Development Review Division

TO: Casey Adragna, Adragna Architecture
FROM: Elizabeth Steward, Associate Planner- Development Review
DATE: 10/27/25
SUBJECT: Douglas 234 Multitenant, Site Plan
Review Comments 02

SITE PLAN
HORSE CREEK COMMERCIAL
 LOT 10B, DOUGLAS 234 FILING NO. 6, AMENDMENT 2
 A PORTION OF THE SW 1/4, SE 1/4, SECTION 29, T6S, R66W, 6TH P.M.
 TOWN OF PARKER, COUNTY OF DOUGLAS, STATE OF COLORADO

COVER SHEET
 DOUGLAS 234 FILING NO. 6, AMD. 2
 JOB NO. 24020
 DATE: OCTOBER 3, 2025
 SHEET C1

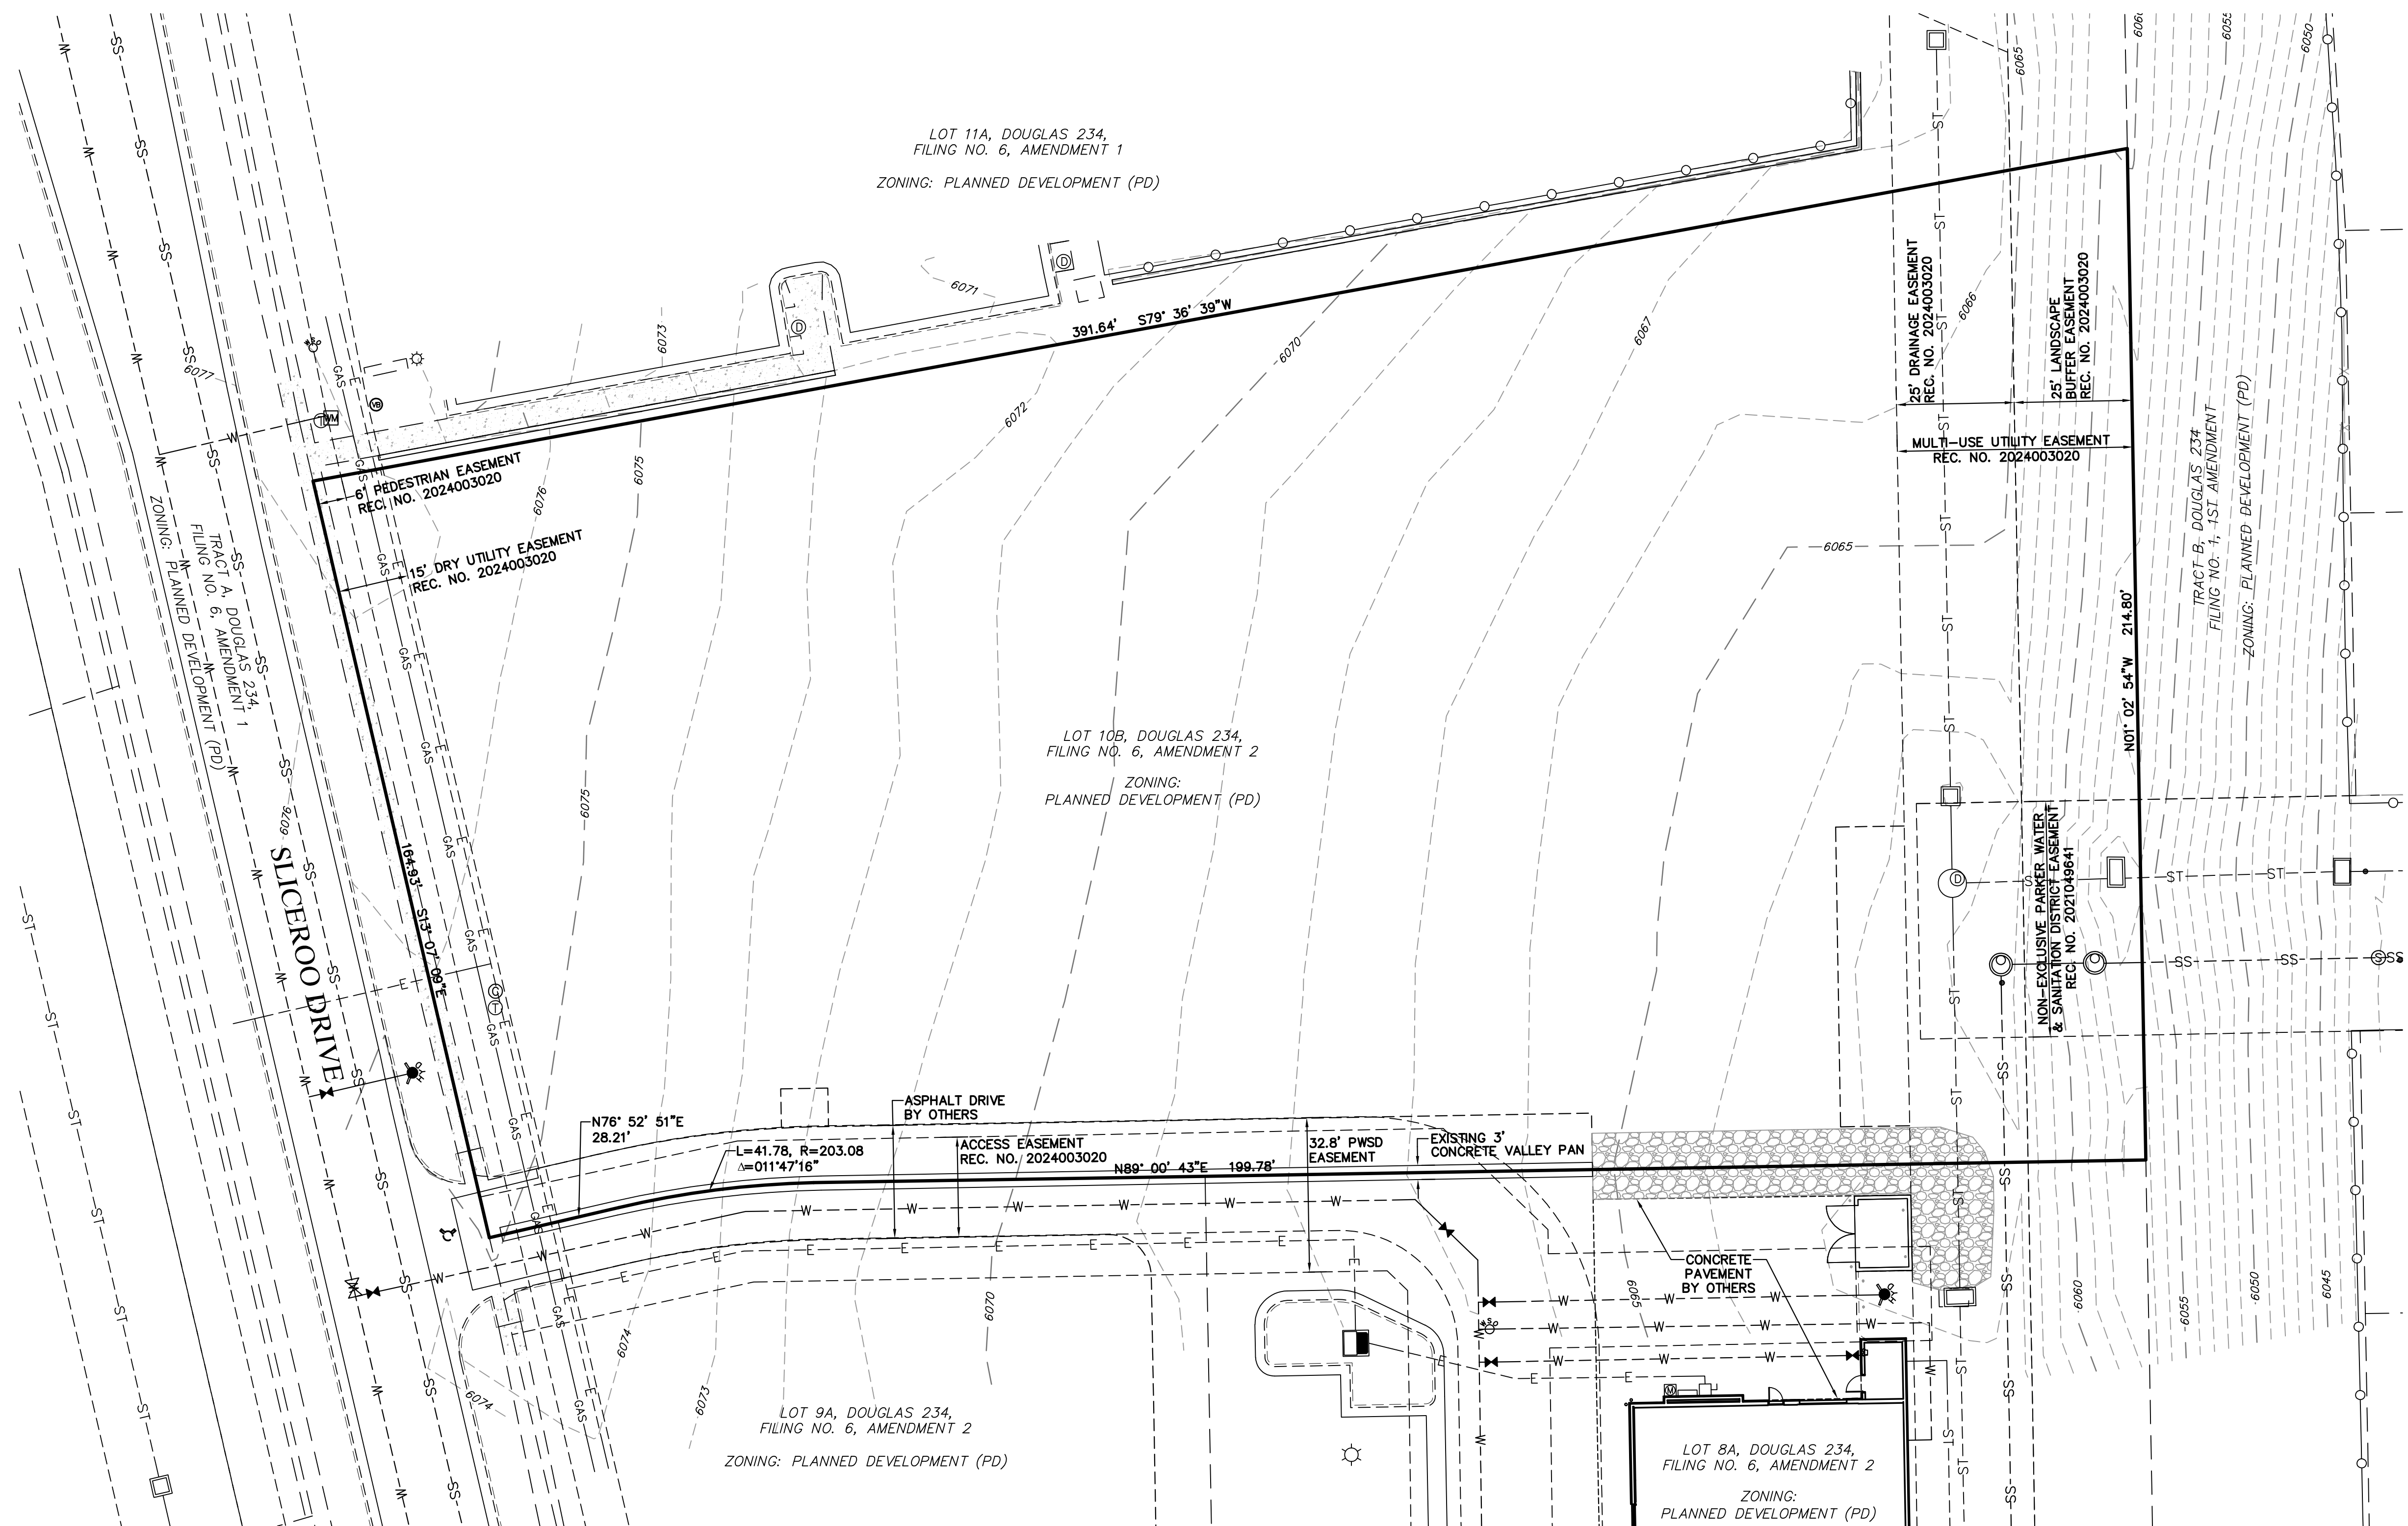
specify that this is the Max Height of structures allowed. This reads that the buildings are required to be 60ft.

SITE PLAN
 DOUGAS 234 FILING NO. 6, AMD. 2
 JOB NO. 24020
 DATE: OCTOBER 3, 2025
 SHEET C3

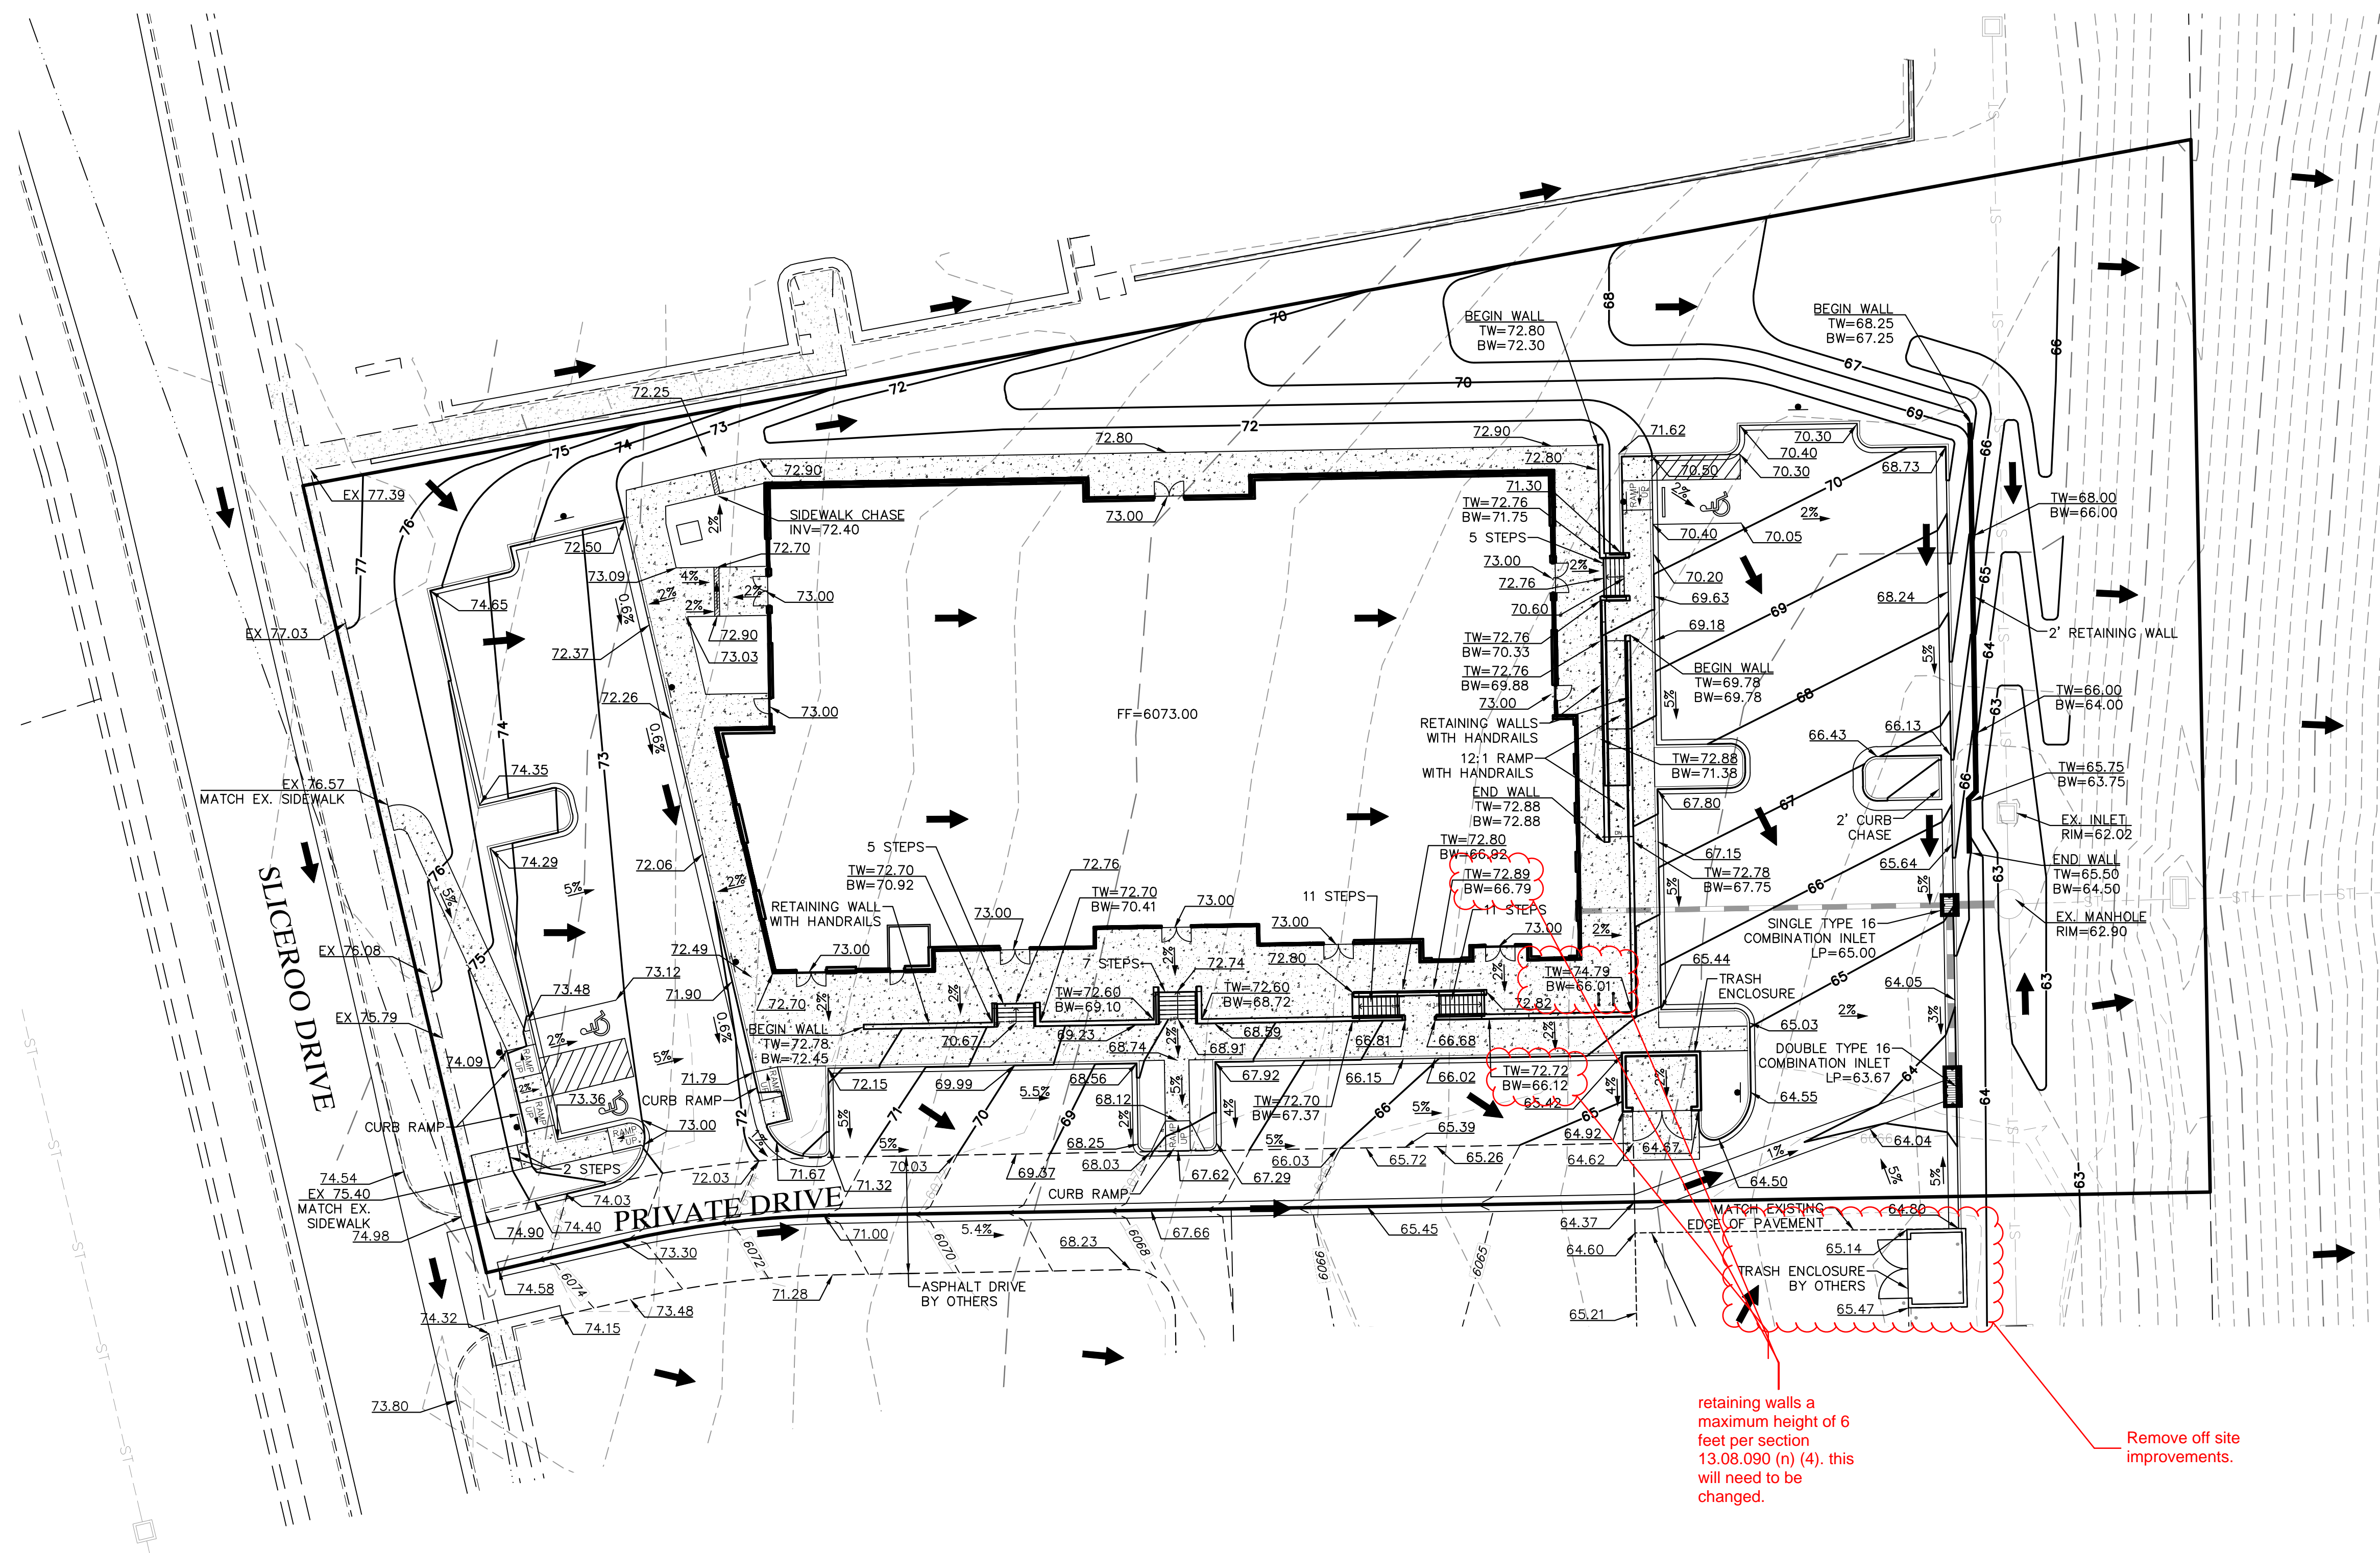
Can the transformer be moved back within this island? Room for screening at the front will be needed.

Bicycle parking is on raised level, this will make it hard to use. Can it be moved to the parking level more towards the frontage of the building? Section 13.08.080 (4) requires Bicycle parking facilities shall be located near building entrances, shall be visible from the primary entrance of the land use they serve

Retaining Walls Cannot exceed 6 feet in height. Correct.

GRADING PLAN
 DOUGAS 234 FILING NO. 6, AMD. 2
 JOB NO. 24020
 DATE: OCTOBER 3, 2025
 SHEET C4

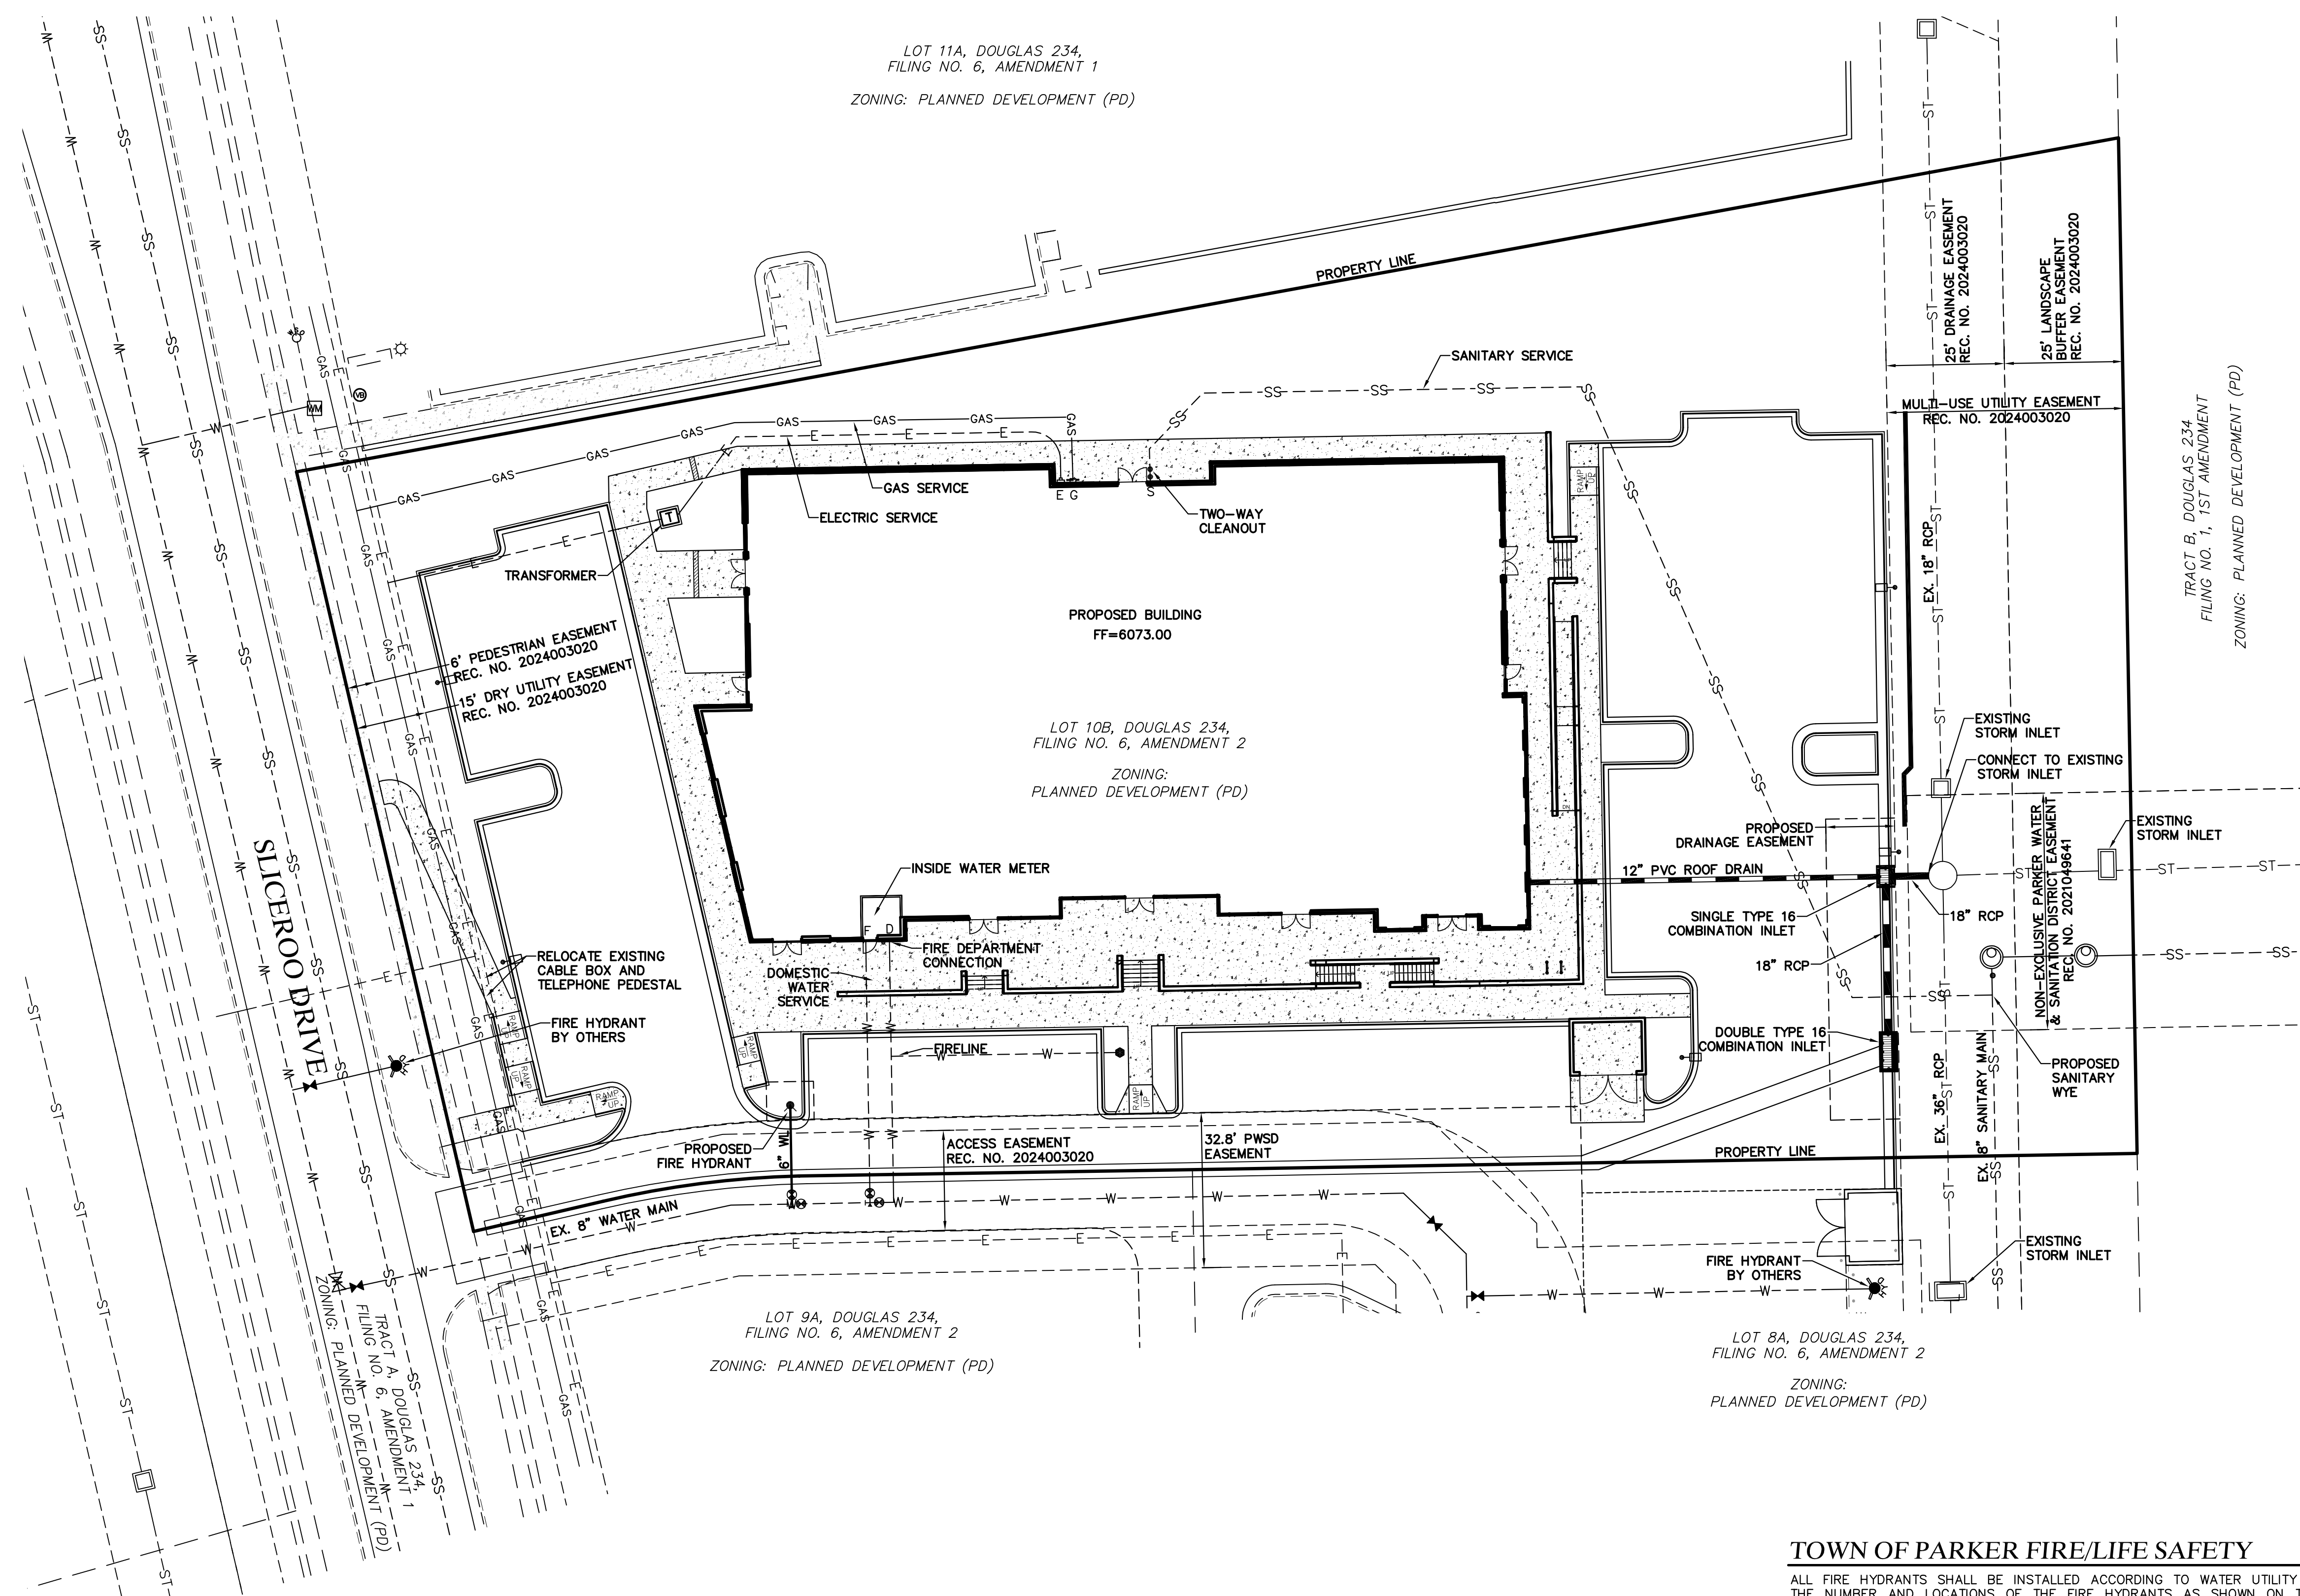
retaining walls a maximum height of 6 feet per section 13.08.090 (n) (4), this will need to be changed.
 Remove off site improvements.
